FIELD SAFETY NOTICE / PRODUCT NOTIFICATION

Subject:	iPlan RT Radiation Treatment Planning Software: MLC leaf gap leakage potentially not correctly calculated when using iPlan RT Dose treatment planning for Elekta Agility MLC.
Product Reference:	iPlan RT Dose / iPlan RT (Versions 4.5.3 and 4.5.4), only in combination with Dose Planning for Elekta Agility MLC.
Date of Notification:	September 13, 2016
Individual Notifying:	Markus Hofmann, Senior MDR & Vigilance Manager
Brainlab Identifier:	CAPA-20160909-001728
Type of action:	Advice regarding use of device; Device modification.

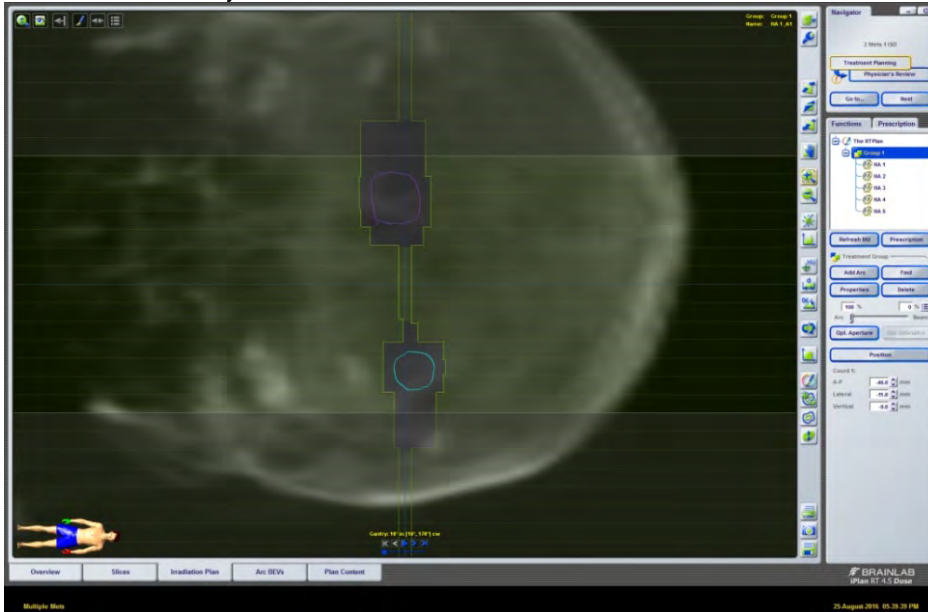
If the above described conditions are met, only specific plans irradiating multiple separate target volumes simultaneously with a single isocenter are affected, since only these plans require the closed MLC leaves to cover the area between the targets without the shielding by the primary jaws. In this case a relevant difference might occur between the displayed and the actual dose distribution that would be irradiated. For illustrations, please refer to the following page.

I) Example of a treatment plan view of multiple separated treatment target volumes to be irradiated simultaneously, with correct display for the Agility MLC: here the remaining gap in between closed leaf pairs is regarded as intended by iPlan RT – the light green lines correctly represent the actual radiation field used by the dose calculation:

II) Examples of dose distribution displays for a single beam:

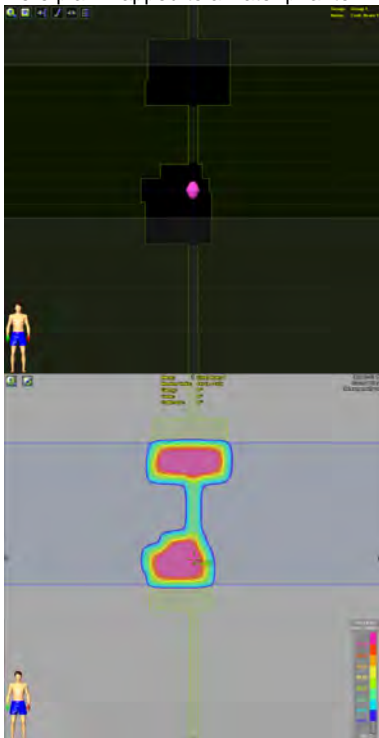
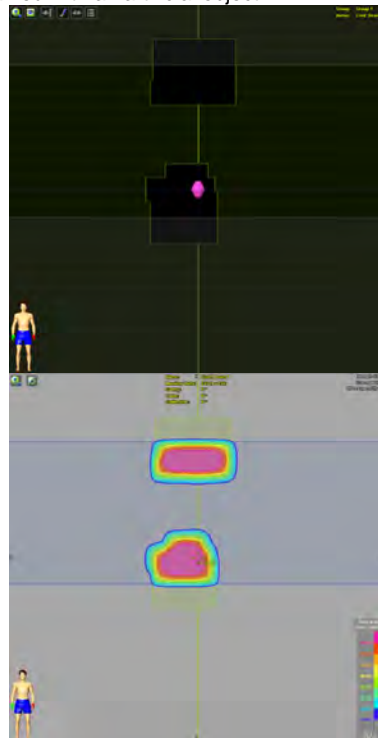
Dose calculation and display **correctly** considering the gaps of closed leaves and their leakage dose (e.g. *Leaf Shift Static* set to 0mm).

Dose calculation and display **not correctly** considering the gaps of closed leaves and their leakage dose (e.g. *Leaf Shift Static* set to 0.2 mm).

- 1) Please immediately check the *Leaf Shift Static* value in all your machine profiles in iPlan RT Dose for an Elekta Agility MLC: **Ensure that this value is set to "0 mm"**. If another value is found, please change this specific value to 0 in order to permanently resolve the described potential issue.
- 2) Please return the attached **Customer Reply Form** to Brainlab.

Location of the *Leaf Shift Static* value

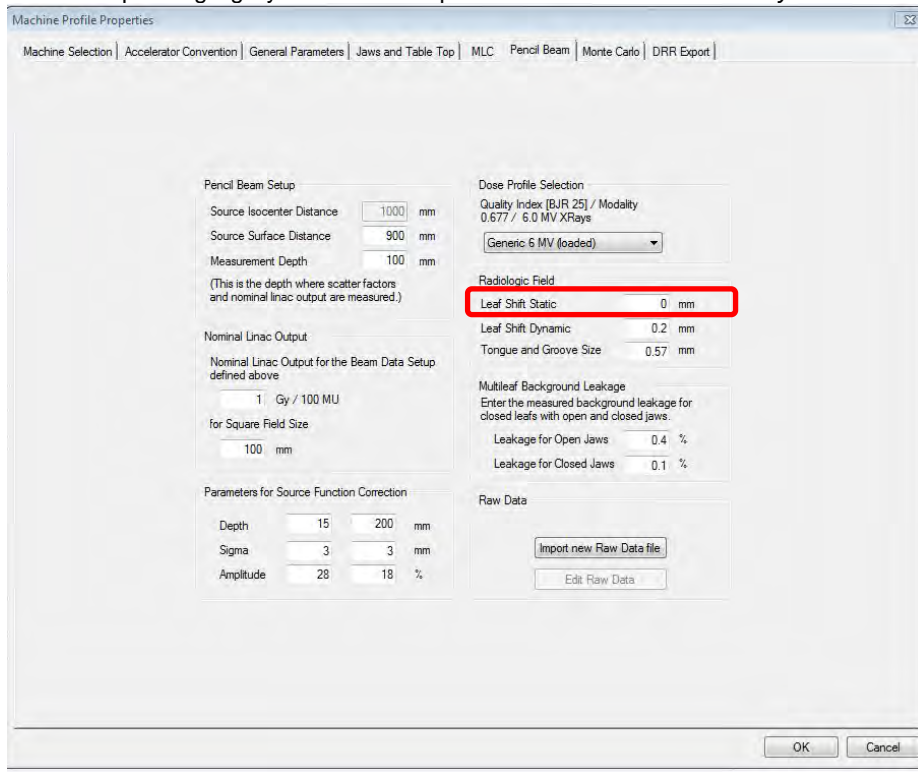
The screenshot shows the 'Machine Profile Properties' dialog box with the 'MLC' tab selected. The 'Radiologic Field' section is highlighted with a red box, showing 'Leaf Shift Static' set to '0 mm'. Other visible settings include 'Pencil Beam Setup' (Source Isocenter Distance: 1000 mm, Source Surface Distance: 900 mm, Measurement Depth: 100 mm), 'Dose Profile Selection' (Quality Index: 0.677 / 6.0 MV X Rays, Generic 6 MV (loaded)), 'Nominal Linac Output' (1 Gy / 100 MU), 'Parameters for Source Function Correction' (Depth: 15, 200 mm; Sigma: 3, 3 mm; Amplitude: 28, 18 %), and 'Multileaf Background Leakage' (Leakage for Open Jaws: 0.4 %, Leakage for Closed Jaws: 0.1 %).
